TECH BULLETIN

066
10/94

SUBJECT: V-Packing change - HP Pumps

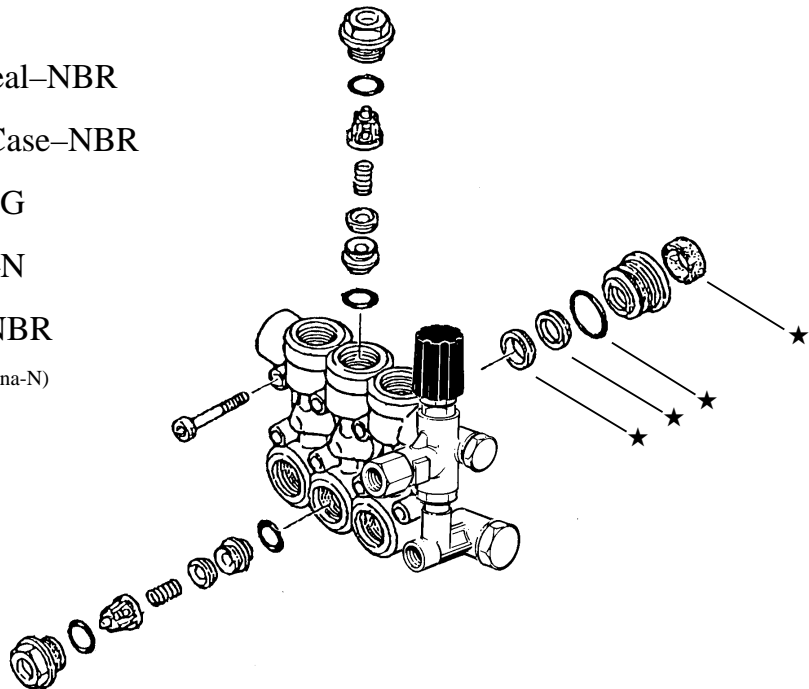
The original production run of 4HP35G1 and 4HP40G1 pumps were built with two V-Packings and a thin Male Adapter.

For added strength under pressure and to keep service time and costs to a minimum, this pump was modified to a single V-Packing and a thicker Male Adapter.

These new parts are available in the seal kit 34062 and will replace the old items during servicing. Discard the old Male Adapter and two V-Packings and use only the new kit parts.
